**CX22™
TRAKBALL
FIELD SERVICE
MANUAL**

FD100660

REV. 01

November 1983

Figure 1. Pin 24 Isolation.

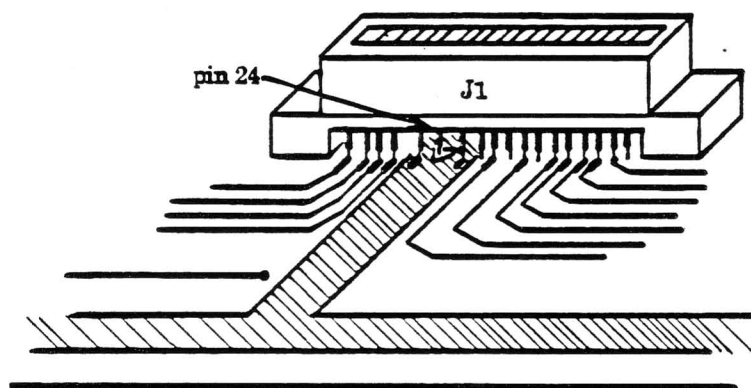
1. Remove the top cover of the CX5200.
2. Verify that the PCB Part Number is CA018087. (If it is not this number, there is no need for the modification. Reinstall cover, insert adaptor, go to step 13 and test.)
3. Remove both the top and bottom PCB shields.
4. Using either an X-ACTO knife or a Dremel tool (150 Bit), isolate Pin 24 of J1 from ground by making a "V" or "U" shaped cut in the trace on the component side of the PCB (See Figure 1). Be careful not to isolate Pins 23 and 25 from ground.

IT IS EXTREMELY IMPORTANT THAT PIN 24 OF J1 BE COMPLETELY ISOLATED FROM GROUND.

Use an Ohm Meter to verify that Pin 24 has been isolated from ground.

Figure 4. Wire Connection Diagram.

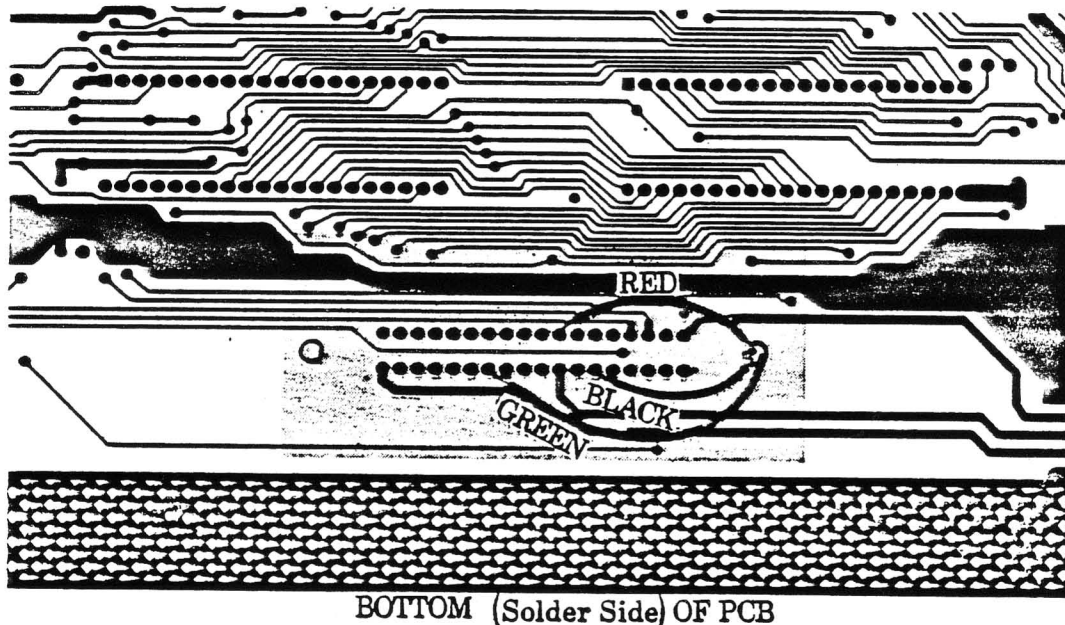
7. Using Figure 4 as a reference, perform the following:

- A. Solder Assembly 1 wire (BLACK) to Pin 24 of J1.
- B. Solder Assembly 2 wire (GREEN) to Pin 30 of J1.
- C. *Solder RED jumper wire to Pin 11 of J1.

After soldering, use an Ohm Meter to make sure that no solder bridges or shorts were formed adjacent to Pins 11, 24, and/or 30 of J1.

* = Take extra care to avoid connecting the RED wire to any ground pins. If the RED wire is grounded, the 5200 Power Adaptor will burn out.

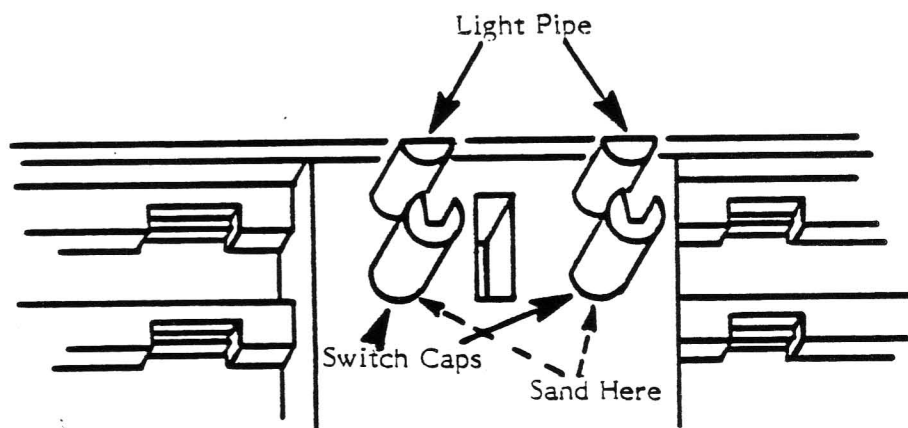
If the switchcaps seem to be binding when activated on Rev. 4 PCBs, tilt the momentary switches (S2-S9) toward the player port side of the board so that there is a .030 inch gap between the board and the leading edge of the switch bottom (a manual approximation is usually successful). Some Rev. 4 PCB's have a shim glued to the PCB to correct this problem.

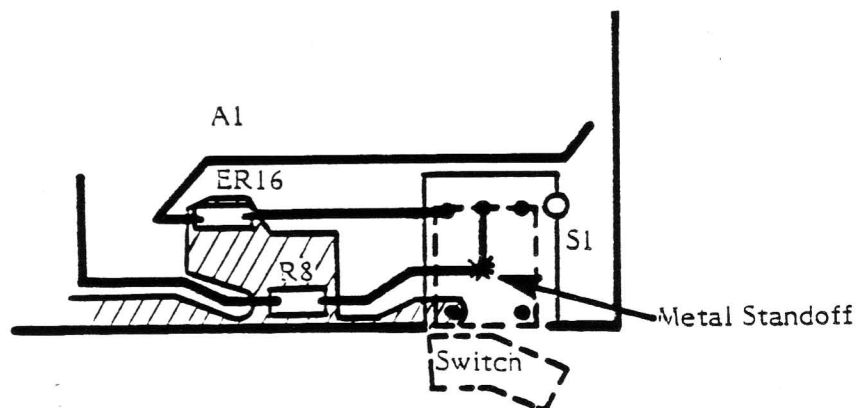
The Rev. 4 CX2800 PCB switch S1 (On/Off) has a metal standoff that may short to the trace beneath the switch. To prevent shorting, place a small piece of insulating tape on the board beneath the switch. PCB to Rev. 4 and above have the traces rerouted.

Figure 1. CX5200 Schematic (R-C Network)

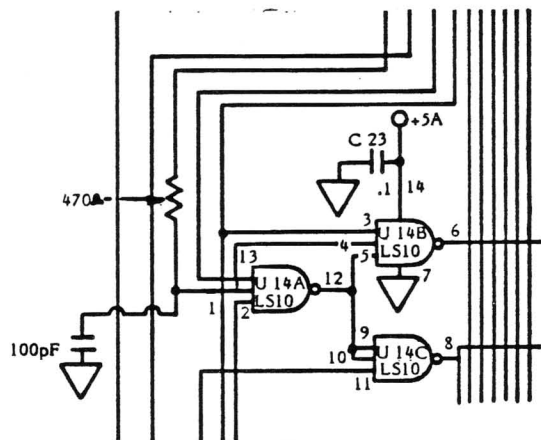
A factory modification adds an R-C network on the component side of the CX5200 PC Board at IC U14A (pin 1) and U6A (pin 4) (see Figures 1 and 2).

Figure 3. R-C Network (Add to solder side of CX 5200 PC Board)

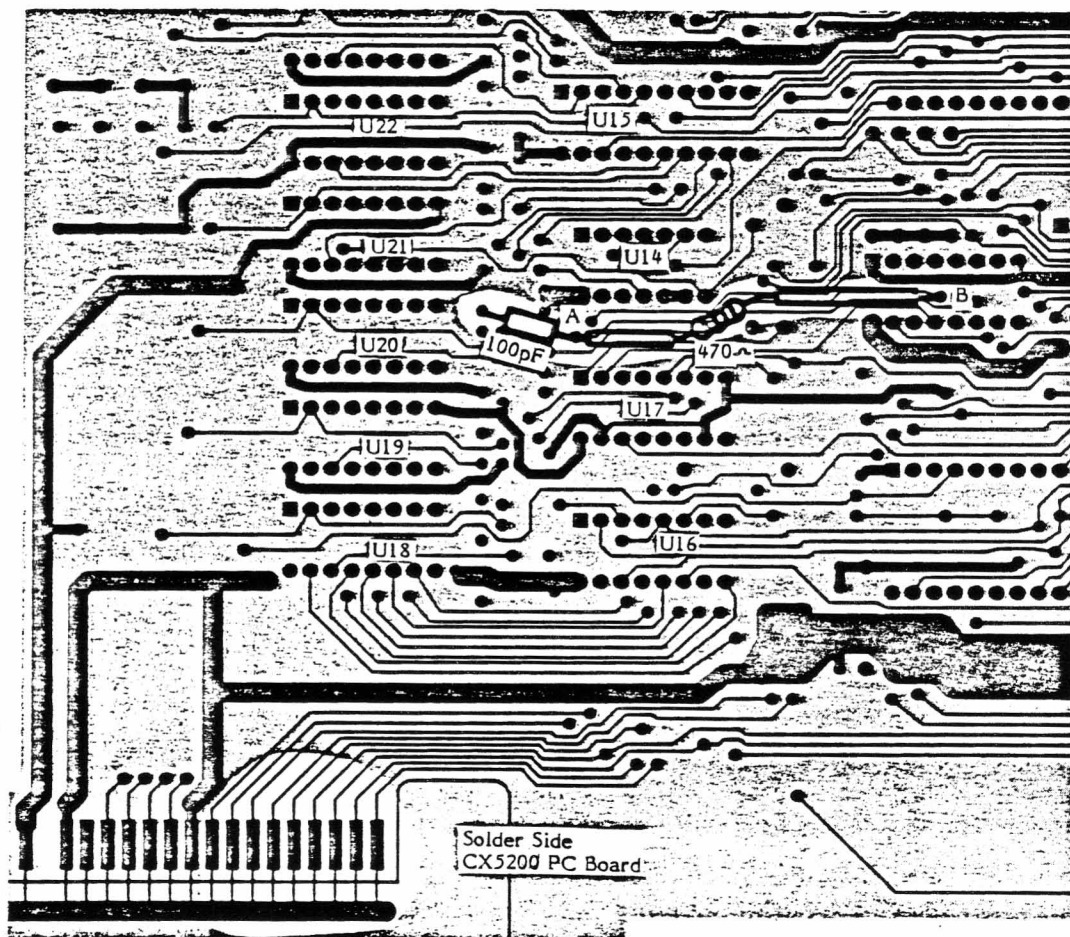
If you are installing an RC stamped 6502 on a CX5200 PC Board which has not had the factory modification added to the component side:

Add an R-C network to the solder side of the PC Board (See Figure 3).

1. Straighten the lead of C27 (solder side) and solder one lead of the 100 pf capacitor to it.
2. Point A is an unoccupied well between IC's U14 and U17. It is connected directly to Pin 1 of U14. Cut the trace running between points A and B as close to Point A as possible. Use a DVM to insure that the trace is now open.
3. Add sleeving to one lead of the 470 Ω resistor. Insert the lead into the well at Point A and solder.
4. Wrap the remaining lead of the 100 pf capacitor around the lead of the 470 Ω resistor at Point A and solder.
5. Remove the solder from well at Point B which is directly beneath U6. Add sleeving to the remaining lead of the 470 Ω resistor. Insert this lead into the hole at Point B and solder.

Old Top Controller Case

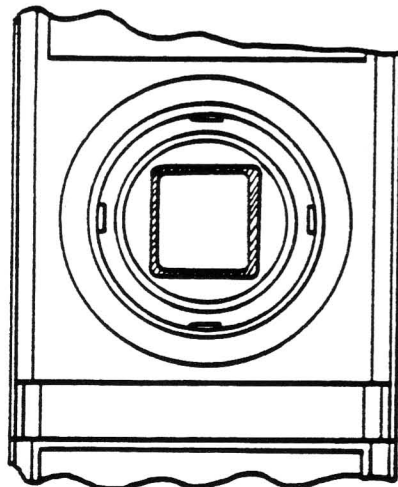
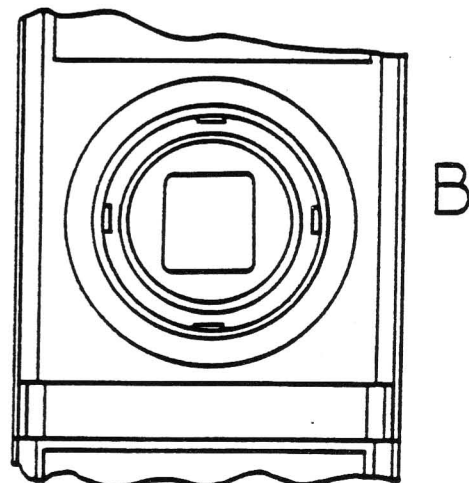
Repair CX5200 Controllers with damaged boots in the following manner:

- 1) Follow Disassembly instructions for the CX5200 Controller in the CX5200 Field Service Manual.
- 2) Remove the top controller case and pull off the joystick handle.
- 3) Remove the boot retaining ring. Remove and discard the damaged boot.
- 4) If the top controller case contains the square ridge around the access well, as illustrated in "A" below, remove and discard it. Replace it with the new top controller case in which this square ridge has been removed, as illustrated in "B".

- 5) Insert new boot, retaining ring, and joystick handle.
- 6) Reassemble controller according to the instructions in the CX5200 Field Service Repair Manual.

Figure 1. 5200 PCB Solder Side at J1

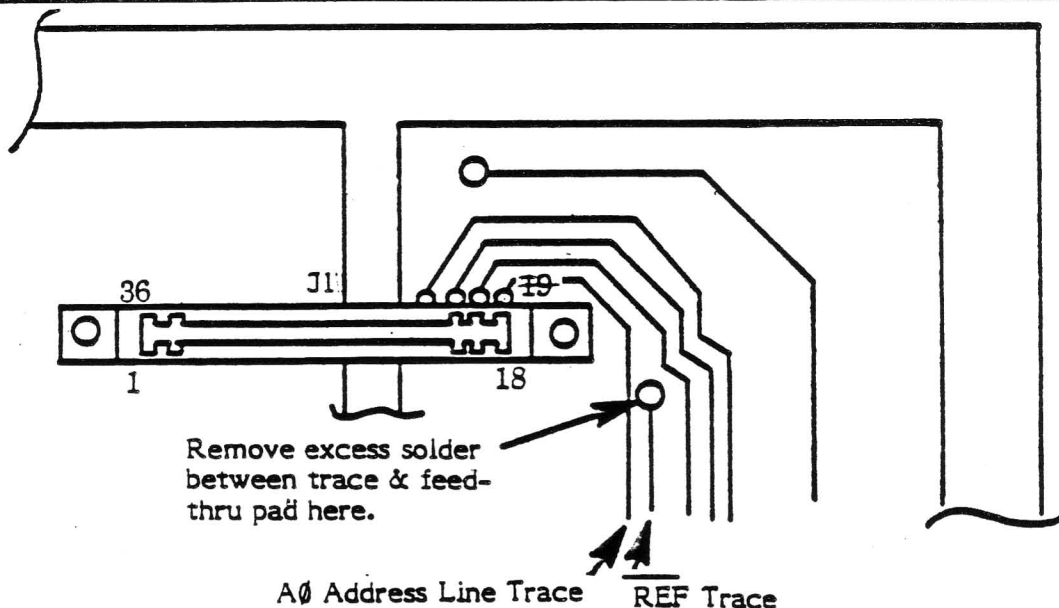
Some 5200 units display a blank dark screen or a screen with garbled information. The probable cause for either of these symptoms is an intermittent solder short (bridge) on the PCB between the A0 Address line trace and the feedthru pad of the REF Line trace (near connector J1).

- 1) Turn off power, and disconnect AC and interconnect cables.
- 2) Disassemble unit to expose the component side of the PCB (CA018087).
- 3) Locate connector J1, the adjacent A0 Address trace and the feed-thru pad of the REF Trace (See Figure 1).
- 4) Carefully remove the excess solder from the pad and wipe the area clean. Inspect the pad and if necessary use an X-acto knife to cut a shallow groove between the A0 Address Line and the feedthru pad. Be very carefully not to nick or cut the trace adjacent to the pad.
- 5) Reassemble and test the unit.

Figure 1. Resistor/Capacitor Fix

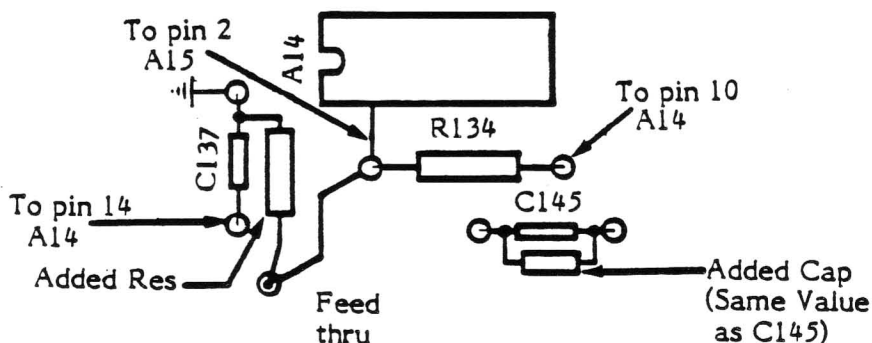
C145 (C014179-24) should be paralleled with another 390pf capacitor (C014179-24) and a 470 Ohm resistor (14-5471) be added from C137 to R134 (See Figure 1).

If the unit still displays a faulty screen, swapout A16 and A17 with another vendor's component. DO NOT USE A SIGNETICS I.C.

Figure 1. Trace Cuts

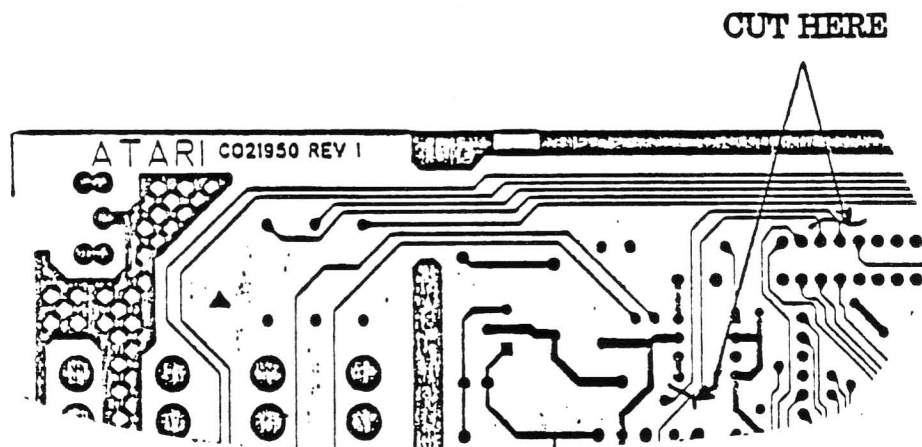
On the solder side of the PCB, use two jumper wires to reroute traces between J1, Pins 15 and 16 and the data bus (See MODIFICATION PROCEDURES).

1. On the solder side of the Adaptor PCB, carefully cut the traces shown in Figure 1.

Figure 2. Jumper Wire Placement

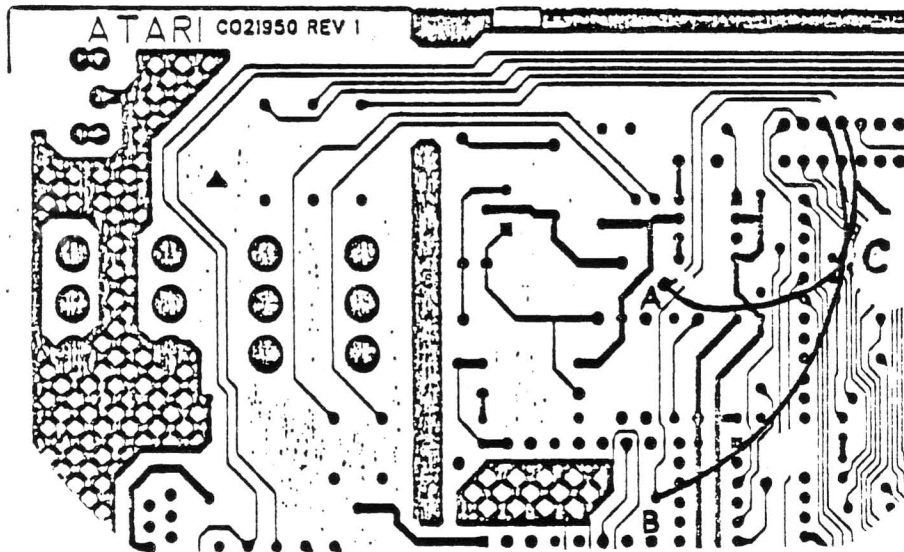
2. Wrap one end of the jumper wire around Pin 15 of J1, and attach the other end of the wire to the feed-thru identified as A in Figure 2 (below R9).
3. Wrap one end of another jumper wire around Pin 16 of J1, and attach the other end of the wire to the feed-thru identified as B in Figure 2 (near the ends of C12 and R14).
4. Use a non-conductive material and tack the jumper wires to the board. Tack the wires at locations identified as C in Figure 2.

Figure 1. Spacer Installation

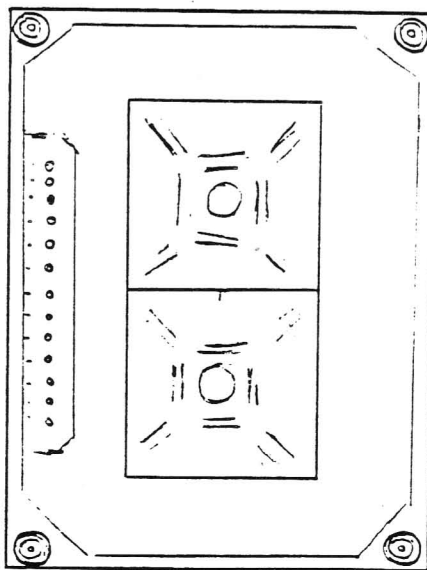
When repairing or replacing a controller assembly, perform the following modification to the controllers keyboard.

- 1) Remove the four nuts and washers that hold the keyboard plate to the control panel.
- 2) Remove the keyboard plate.
- 3) Install spacers (see Figure 1).

Figure 1. Hole Cover Placement

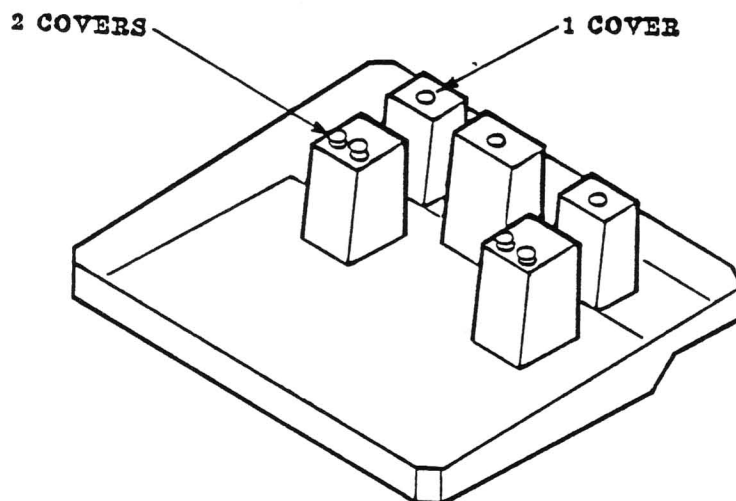
Use eleven ATARI 810™ Disk Drive hole covers (C014106) and place them in the positions on the bottom case shown in Figure 1.
